# A d d e n d u m

Iowa Department of Transportation  
Office of Contracts

<b>B.O.</b>	<b>Proposal ID</b>	<b>Proposal Work Type</b>	<b>County</b>	<b>Project Number</b>	<b>Addendum</b>
005	42-C042-077-A	BRIDGE AND APPROACHES - CCS	HARDIN	BRS-C042(77)--60-42	20OCT005.A01

PROJECT NO. BRS-C042(77)---60-42 HARDIN COUNTY STEEL BEAM GUARDRAIL BARRIER TRANSITION SECTION

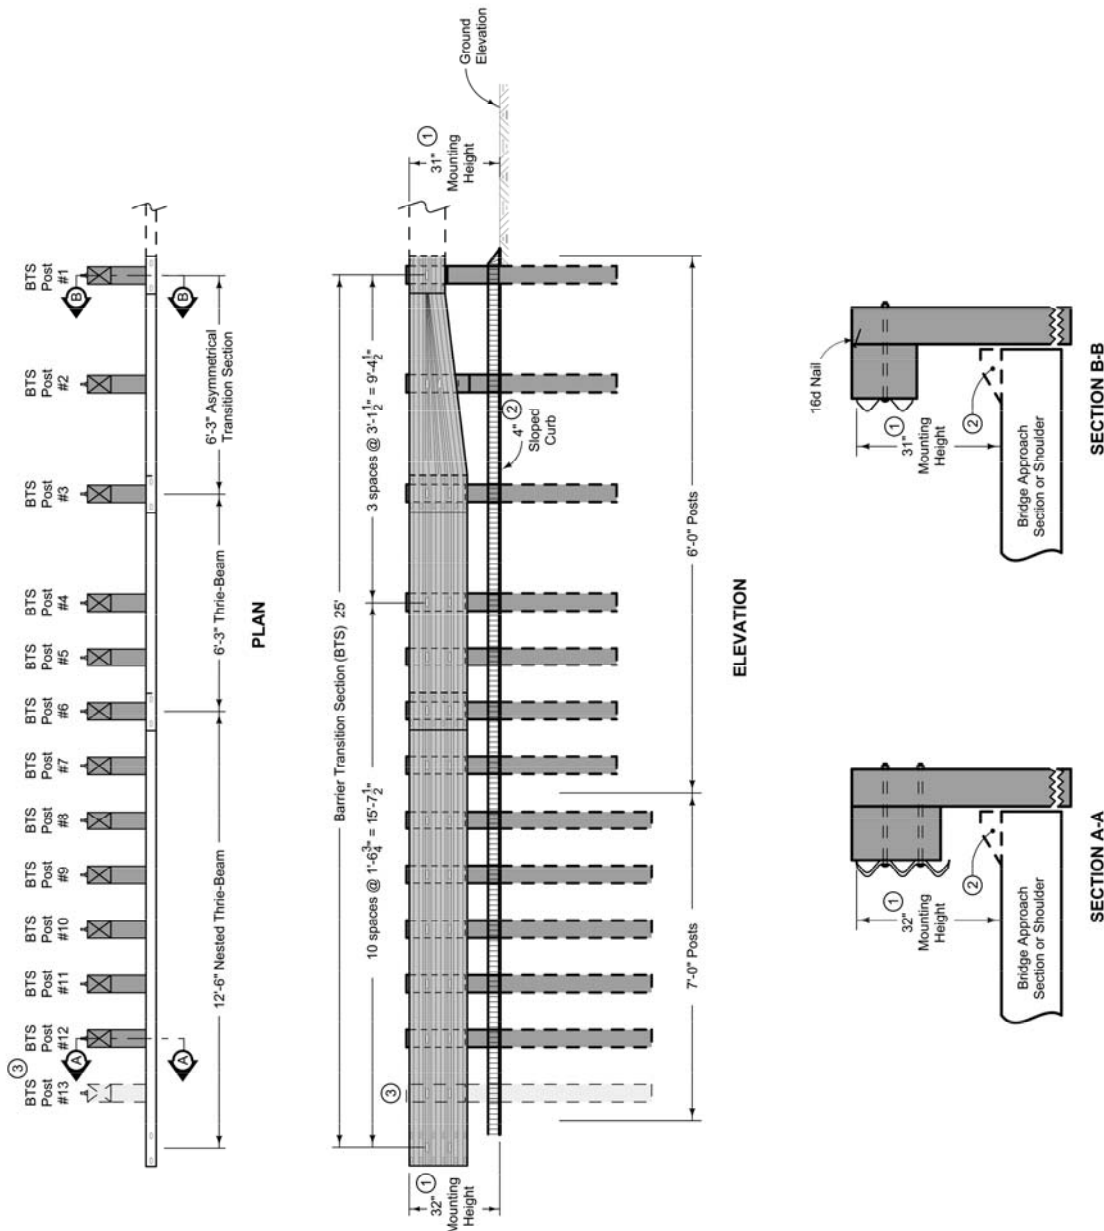
Insert plans with the attached sheets 19 - 24.
